LiPo Charger

Revision Notes

Changes to v13 (date:4/3/12)

Switching Regulator

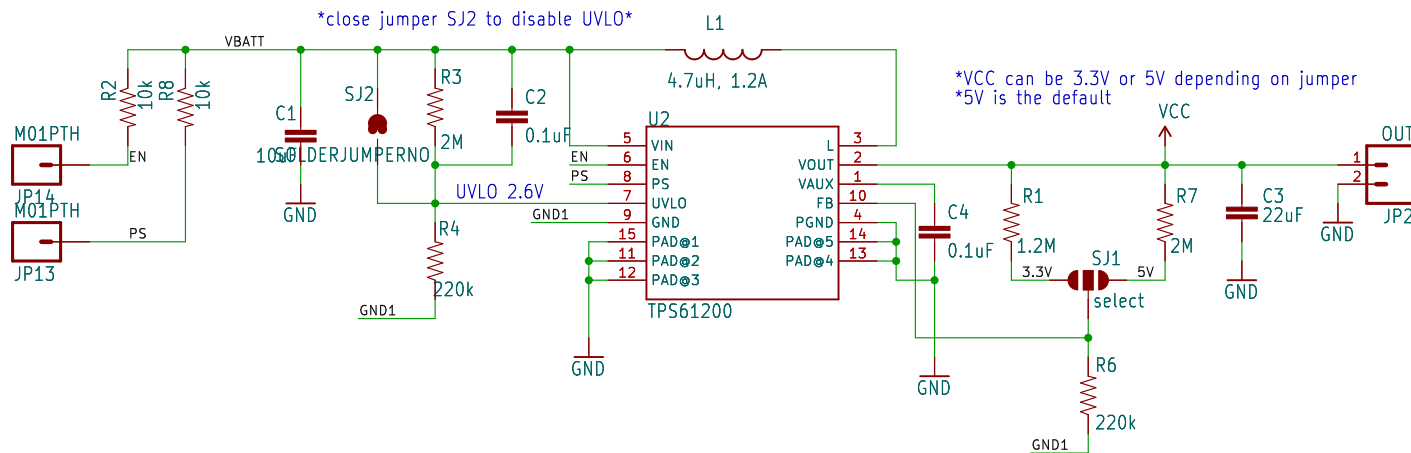
- added breakout pins for PS and EN
- Route traces on IC directly away from pads to prevent uneven reflow
- move vias under IC so they're not as close to side ground pads
- added jumper to disable UVLO
